Proposal for the 02 series of amendments to the UN Regulation No. 134 with regard to the safety-related performance of hydrogen-fuelled vehicles (HFCV) – consolidated text

Submitted by the task force amending UN Regulation No.134 *

The text reproduced below was prepared by the task force involving France, Japan, the Netherlands, the European Commission, European Association of Automotive Suppliers (CLEPA) and the International Organization of Motor Vehicle Manufacturers (OICA) as well as related industry experts in order to transpose the amendment 1 to UN Global Technical Regulation No. 13, Phase 2 (GTR13-PH2) into the UN regulation under the 1958 Agreement. This document is based on informal document GRSP-72-17, distributed at the seventy-second session of the Working Party on Passive Safety (GRSP) with the incorporation of further amendments that have been addressed at the task force. The modifications to the existing text of the UN Regulation No, 134 are marked in bold for new or strikethrough for deleted characters and the modifications from ECE/TRANS/WP.29/GRSP/2023/08 are given **in red fonts**.

Figure 1
Typical compressed hydrogen storage system

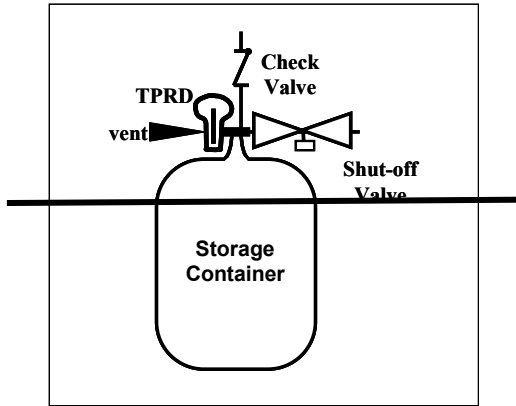
~~The hydrogen storage system consists of the high pressure storage container and primary closure devices for openings into the high pressure storage container. Figure 1 shows a typical compressed hydrogen storage system consisting of a pressurized container, three closure devices and their fittings. The closure devices shall include the following functions, which may be combined:~~

- (a) ~~TPRD;~~
- (b) ~~Check valve that prevents reverse flow to the fill line; and~~
- (c) ~~Automatic shut off valve that can close to prevent flow from the container to the fuel cell or internal combustion engine. Any shut off valve, and TPRD that form the primary closure of flow from the storage container shall be mounted directly on or within each container. At least~~

The primary closure devices that isolate the high pressure hydrogen storage system, namely TPRD, check valve and shut-off valve, ~~as described in Figure 1,~~ shall be tested and type-approved in accordance with Part II of this Regulation and produced in conformity with the approved type.

Figure 12
Verification test for performance durability (hydraulic)

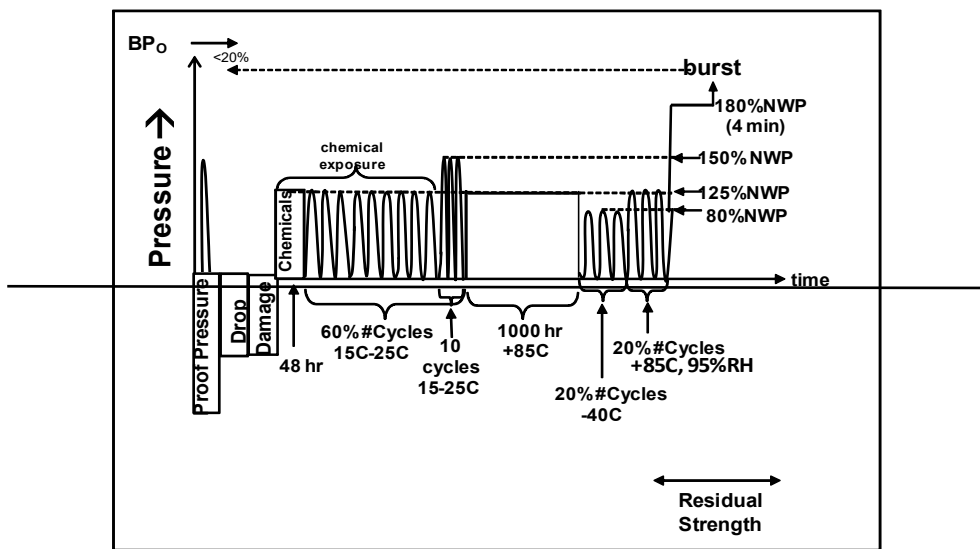
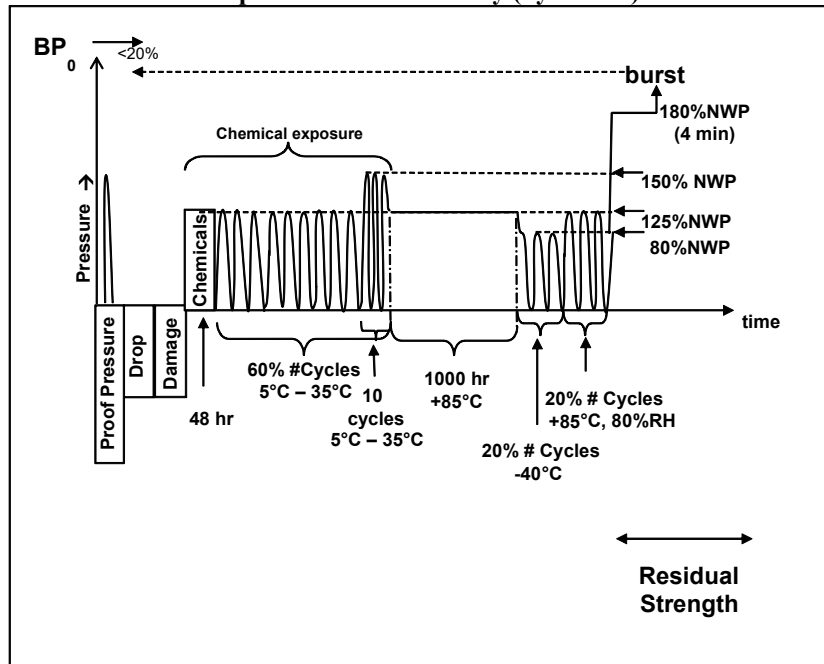
~~A hydrogen storage system~~ **The container shall not leak during the following sequence of tests, which are applied in series to a single system and which are illustrated in Figure 12. Specifics of applicable test procedures for the hydrogen storage system are provided in Annex 3, paragraph 3.**

Figure 23
Verification test for expected on-road performance (pneumatic/hydraulic)

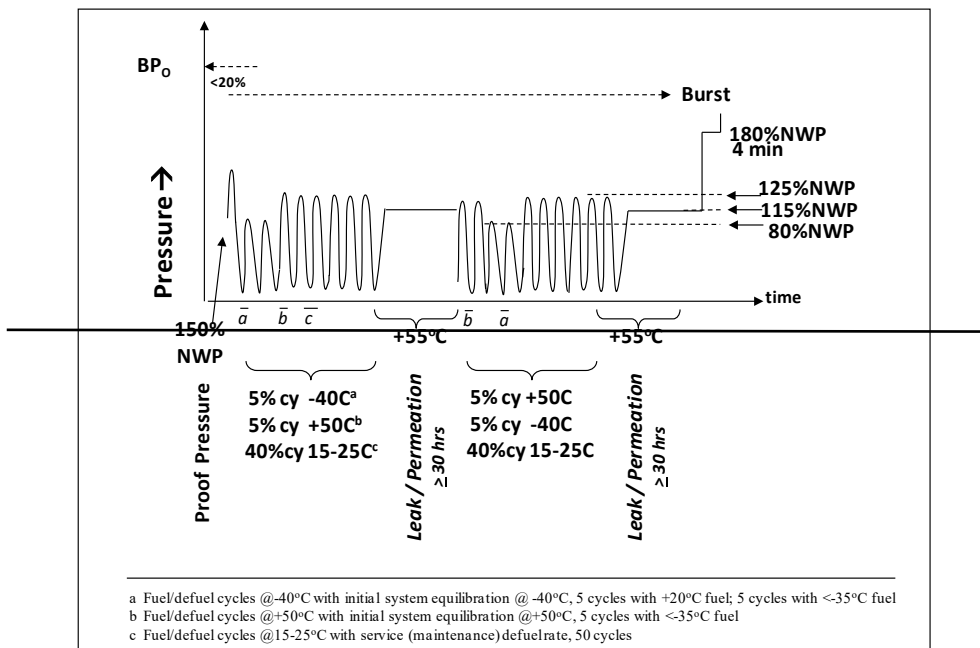
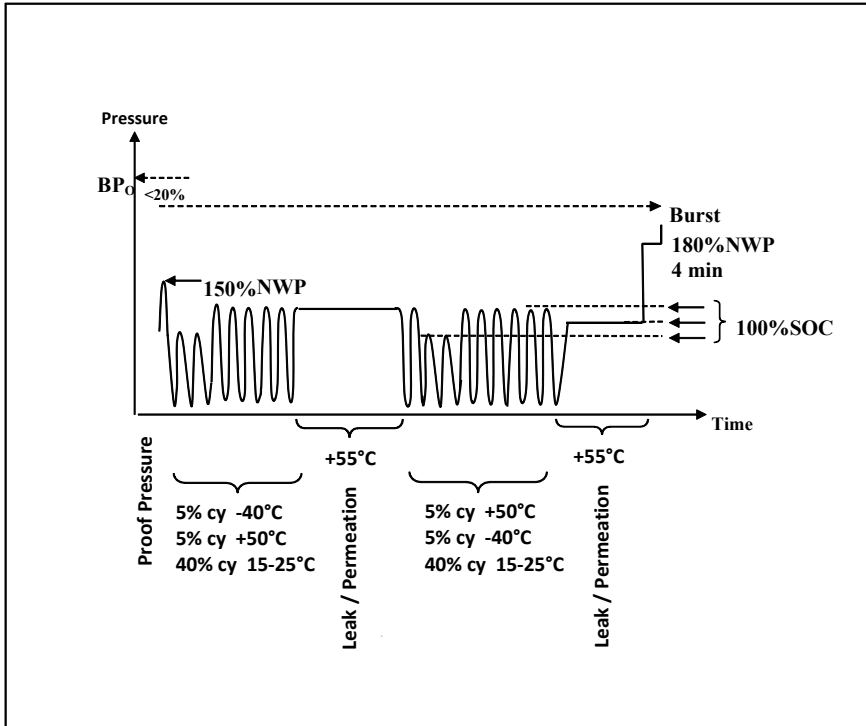
~~A hydrogen storage system~~ CHSS shall **undergo not leak** during the following sequence of tests, which are illustrated in Figure 23. Specifics of applicable test procedures for the ~~CHSS hydrogen storage system~~ CHSS are provided in Annex 3.

The CHSS shall not leak and the primary closure devices shall maintain functionality during the test.

~~(a) The pressure cycles are divided into two groups: Half of the cycles (250) are performed before exposure to static pressure (paragraph 5.3.3.) and the remaining half of the cycles (250) are performed after the initial exposure to static pressure (paragraph 5.3.3.) as illustrated in Figure 3;~~

Figure 1
Drop orientations

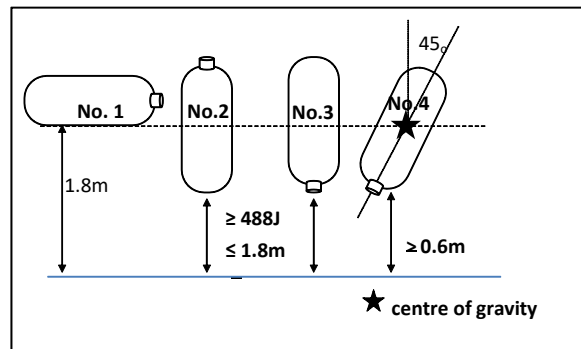
- (iv) ~~Dropped once at~~ ~~From~~ ~~a 45° angle from the vertical orientation with the shut-off valve interface location~~ ~~a~~ ~~ported end~~ ~~downward with its centre of gravity~~ ~~\leq at~~ ~~1.8 m above the ground. However, if the bottom is closer to the ground than 0.6 m, the drop angle shall be changed to maintain a minimum height of 0.6 m and a centre of gravity~~ ~~of~~ ~~\leq at~~ ~~1.8 m above the ground.~~ **In case of non-axisymmetric container, the line passing the shut-off valve interface location end and its centre of gravity shall be 45° angled from vertical orientation and the shut-off valve interface location shall become the lowest.**

The four drop orientations are illustrated in Figure 1.

Figure 32
Side view of container

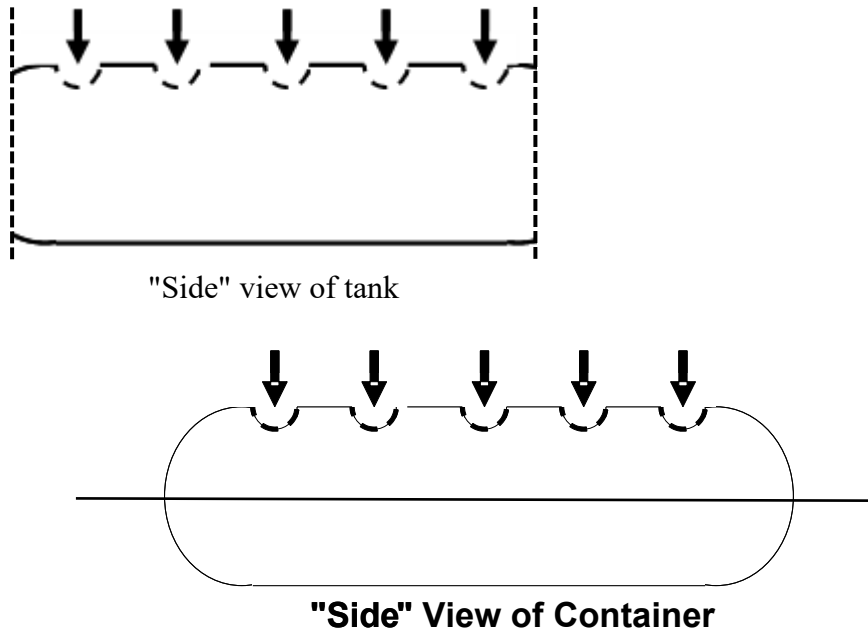
- (b) Pendulum impacts: A surface of the test article opposite to the surface specified above or a surface of a different chamber, in the

case of a container with multiple permanently interconnected chambers, ~~The upper section of the horizontal storage container is divided into five distinct (not overlapping) areas 100 mm in diameter each (see Figure 32). After~~ **Immediately following a minimum of 12** hours preconditioning at ≤ -40 °C in an environmental chamber, the centre of each of the five areas sustains the impact of a pendulum having a pyramid with equilateral faces and square base, the summit and edges being rounded to a radius of 3 mm. The centre of impact of the pendulum coincides with the centre of gravity of the pyramid. The energy of the pendulum at the moment of impact with each of the five marked areas on the container is ≥ 30 J. ~~The container test article is~~ secured in place during pendulum impacts and not under pressure.

Figure 3
Temperature profile of fire test

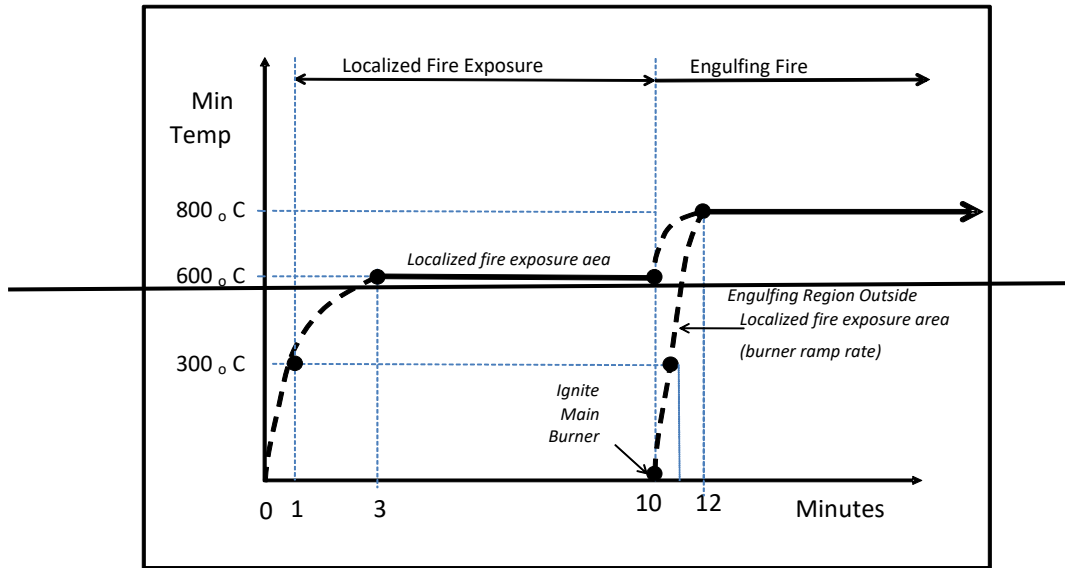
- ~~(iii) Wind shields are applied to ensure uniform heating;~~
 - ~~(iv) The fire source initiates within a 250 (± 50) mm longitudinal expanse positioned under the localized fire exposure area of the test article. The width of the fire source encompasses the entire diameter (width) of the storage system. If Method 2 is selected, the length and width shall be reduced, if necessary, to account for vehicle specific features;~~

- ~~(v) As shown in Figure 3 the temperature of the thermocouples in the localized fire exposure area has increased continuously to at least 300 °C within 1 minute of ignition, to at least 600 °C within 3 minutes of ignition, and a temperature of at least 600 °C is maintained for the next 7 minutes. The temperature in the localized fire exposure area shall not exceed 900 °C during this period. Compliance to the thermal requirements begins 1 minute after entering the period with minimum and maximum limits and is based on a 1-minute rolling average of each thermocouple in the region of interest. (Note: The temperature outside the region of the initial fire source is not specified during these initial 10 minutes from the time of ignition.);~~~~
